Sub :- Diversion of 18.94 ha of forest land in favour Minor Irrigation Division, Sindhudurg for construction of Minor Irrigation Tank in Village- Nirukhe, Taluka- Kudal, District- Sindhudurg in the State of Maharashtra- regarding

DDGF©/Regional Officer (Central), Integrated Regional Office, MoEF&CC, Nagpur vide their letter under above reference has raised some queries in Diversion of 18.94 ha of forest land in favour Minor Irrigation Division, Sindhudurg for construction of Minor Irrigation Tank in Village- Nirukhe, Taluka- Kudal, District- Sindhudurg proposal, the point wise compliance of the same is submitted herewith

Certificate regarding Employment generation/Man days for Proposal for Diversion of Forest Land for Construction of Minor Irrigation Tank in Nirukhe Village Tal- Kudal, Dist- Sindhudurg

SOI TOPOSHEET INDICATING PERENNIAL AND INTERMITTENT STREAM NETWORK IN PROPOSED MINOR IRRIGATION TANK IN NIRUKHE VILLAGE TAL- KUDAL DIST- SINDHUDURG

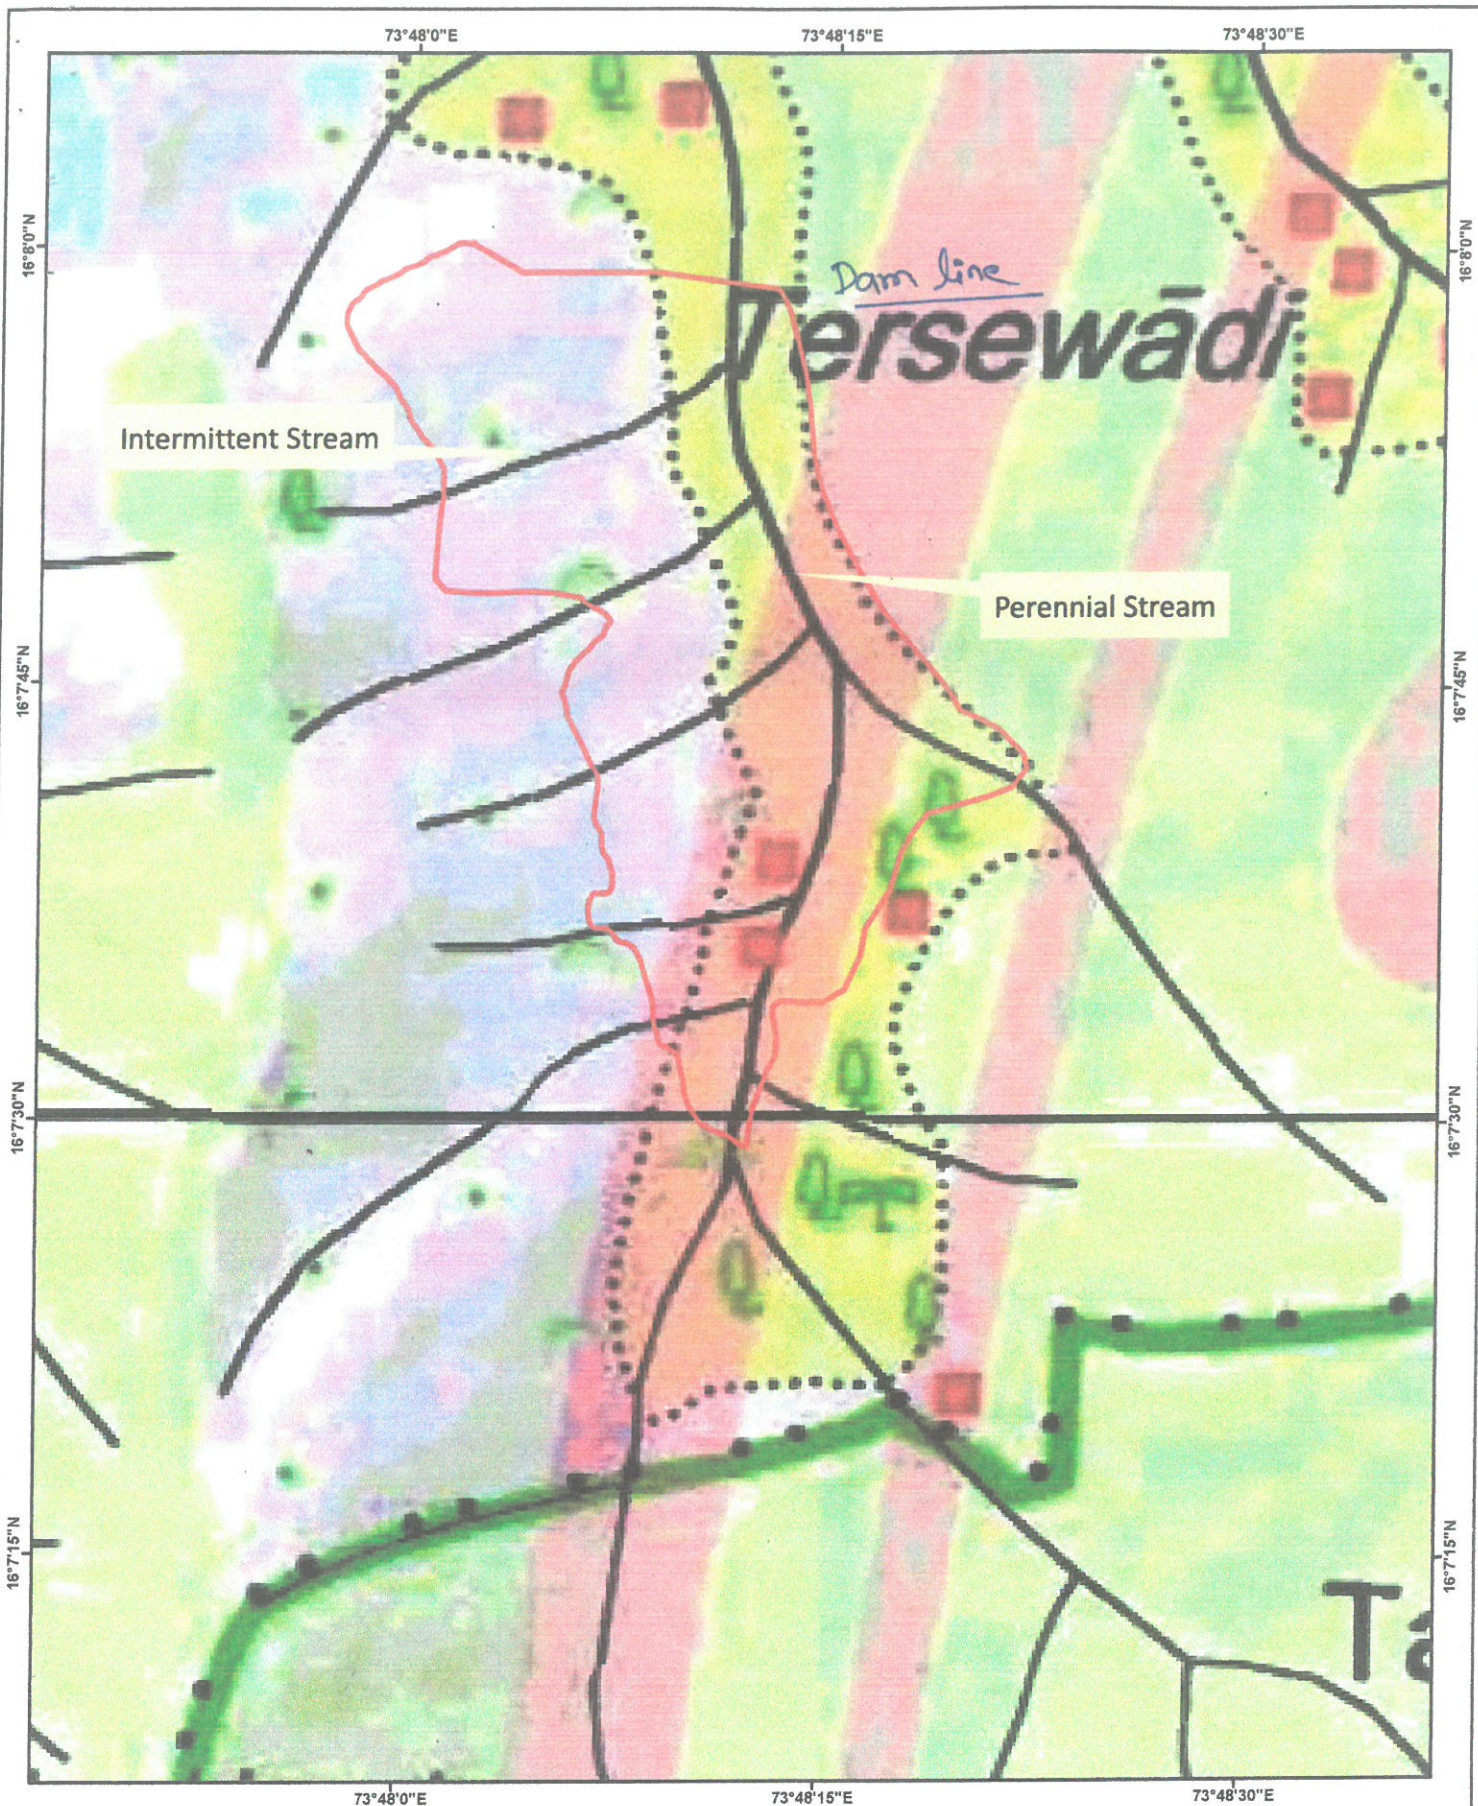
v	Details of employment potential in terms of man days of skilled, semiskilled and unskilled persons on permanent (direct and indirect) and temporary (direct and indirect) basis have not been provided. The same needs to be provided.	The details showing employment potential in terms of man days of skilled, semiskilled and unskilled persons on permanent (direct and indirect) and temporary (direct and indirect) basis is submitted in separate certificate.
vi	No maps submitted along with the proposal is certified by DCF concerned. All requisite maps certified by DCF concerned needs to be submitted.	The maps are submitted herewith for having signatures.
vii	Certificate related to recognition and vesting of forest rights in accordance with the provisions of the Scheduled Tribes and Other Traditional Forest Dwellers (Recognition of Forest Rights) Act, 2006 is submitted for 28.05 ha along with the proposal. Certificate for exact area proposed for diversion along with supporting documents shall be submitted. State Government shall ensure settlement of rights under the Scheduled Tribes and Other Traditional Forest dwellers (Recognition of Forest Rights) Act, 2006 (No.2 of 2007) before issue of Stage – II approval.	Issuance of Certificate related to recognition and vesting of forest rights in accordance with the provisions of the Scheduled Tribes and Other Traditional Forest Dwellers (Recognition of Forest Rights) Act, 2006 is under process at SDO, Kudal office; it will be submitted by the State Government before issue of Stage – II approval.

Temporary Employee requirement of project				Total man days per annum
Sr. No.	Description	Temporary Employment		
		Direct	Indirect	
1	Skilled	19	8	120 X 50 = 6000 man days
2	Semi-Skilled	10	4	
3	Unskilled	5	4	
Total		34	16	
Grand Total		50		
Total days of employment for temporary employee in year is 120 days				
Permanent Employee requirement of project				365X 10 = 3650 man days
Sr. No.	Description	Permanent Employment		
		Direct	Indirect	
1	Skilled	4	2	
2	Semi-Skilled	2	1	
3	Unskilled	1	0	
Total		7	3	
Grand Total		10		
Total days of employment for permanent employee in year is 365 days				
Total employment generation per annum in man days for skilled, semiskilled and unskilled persons on permanent (direct and indirect) and temporary (direct and indirect) basis				9650 man days

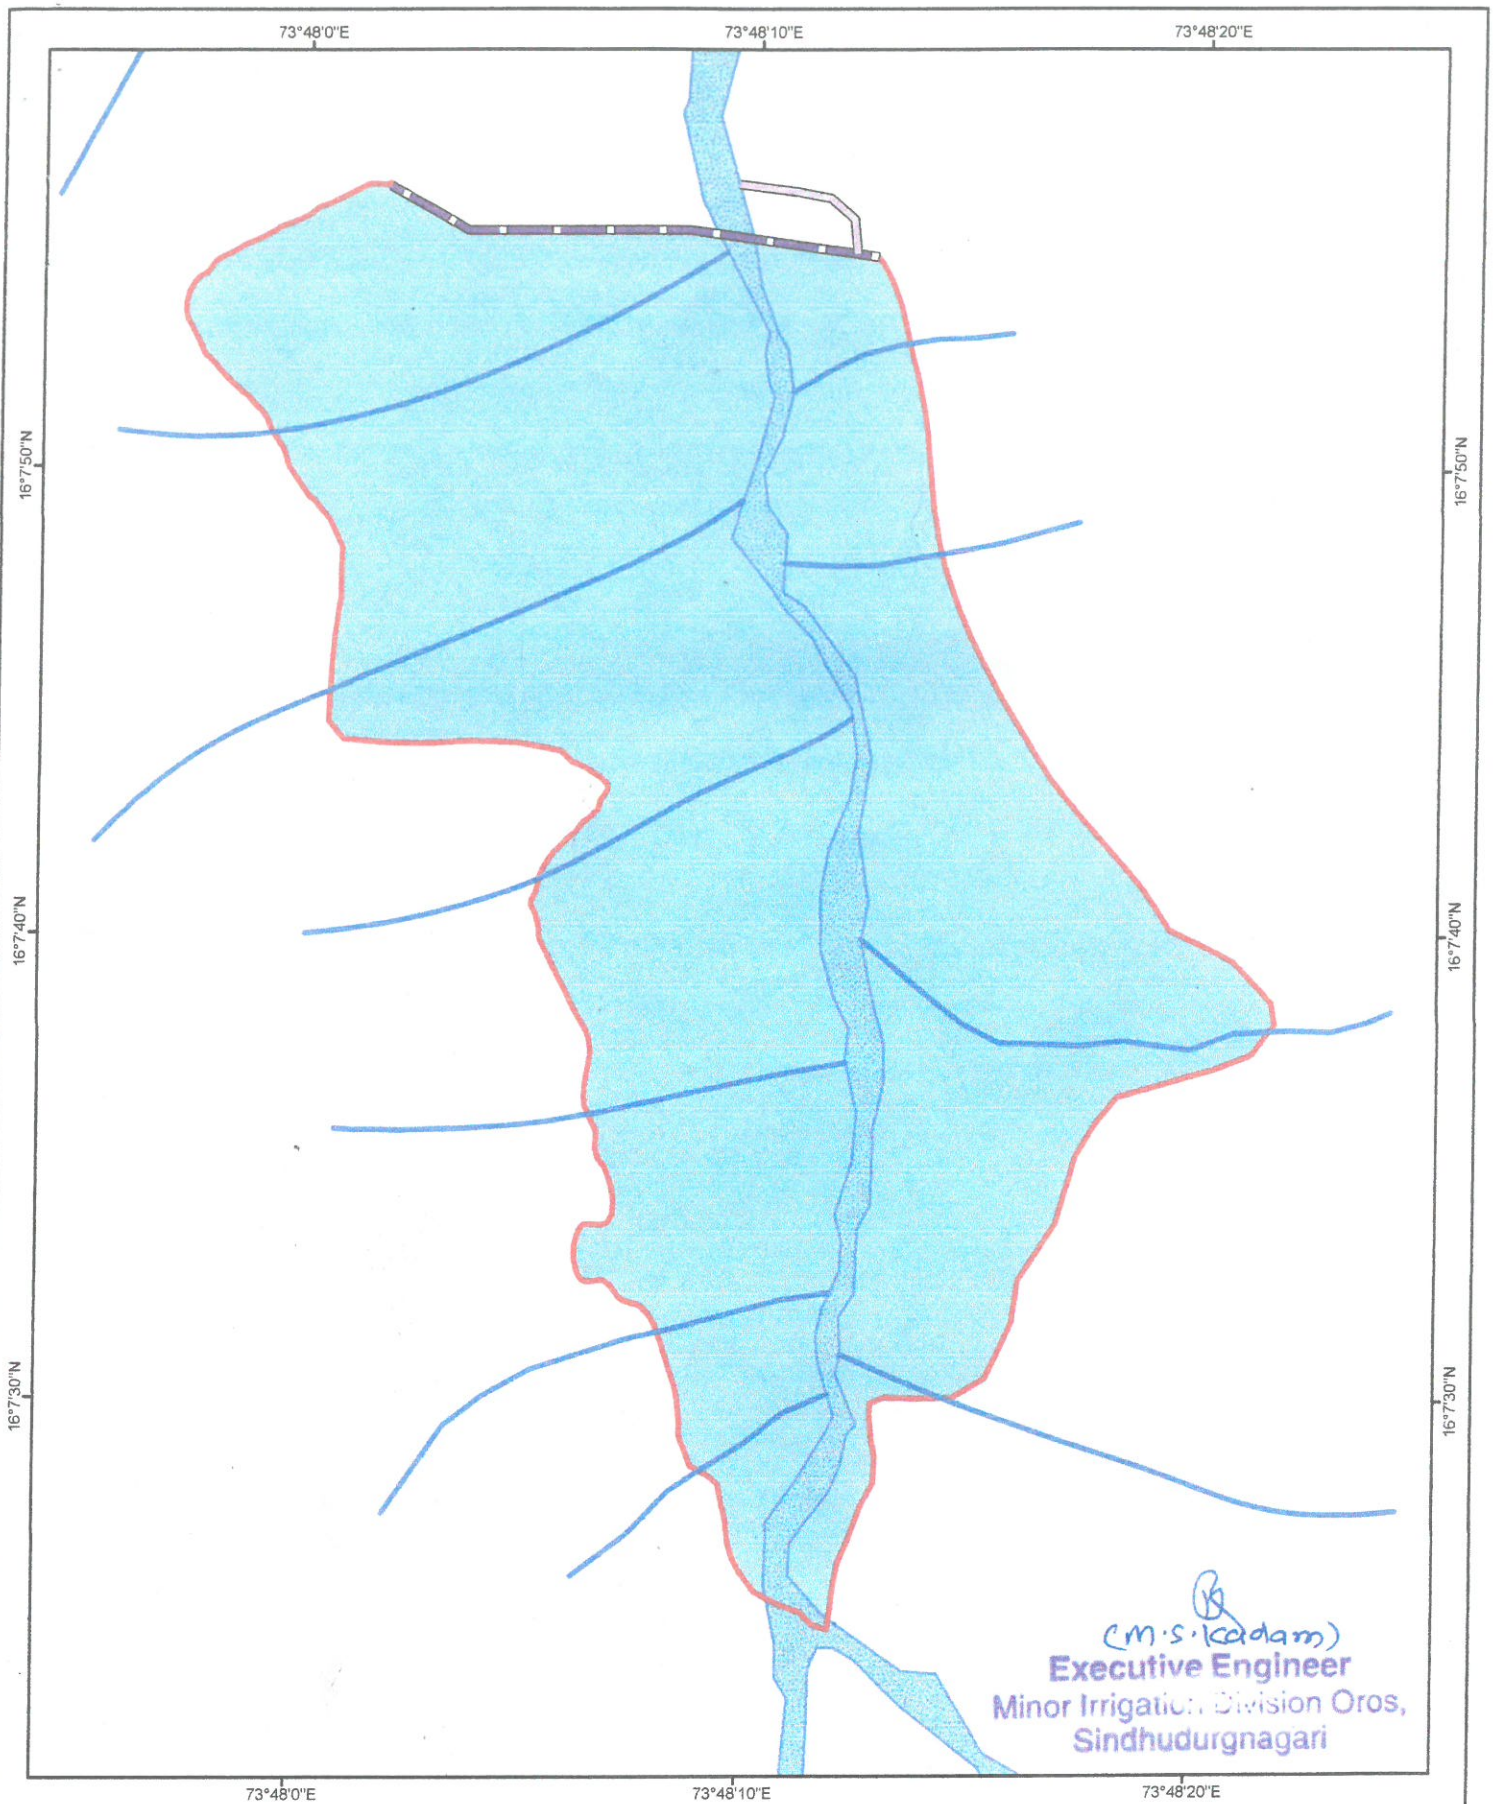
Sr. No.	Point raised	Compliance
iii	After examination of the Google satellite imagery it has been found that no seasonal or perennial stream is visible in area to feed the proposed tank. The details of stream proposed to utilize for the dam along with its season-wise annual flow regime needs to be submitted.	There is dense tree cover over the feeding stream area of the project, due to which Google satellite imagery is not showing any seasonal or perennial stream. The project is having yield from perennial streams in the catchment of the project which is 2.54 square KM. The perennial streams are seen in Toposheet related to the project catchment area the copy of the same is attached for ready reference
iv	Details on progressive CA done till date in the Division is not mentioned by Deputy Conservator of Forests, Sawantwadi in his Part- 11. Revised Part- 11 mentioning the same shall be submitted.	This point related to forest department.
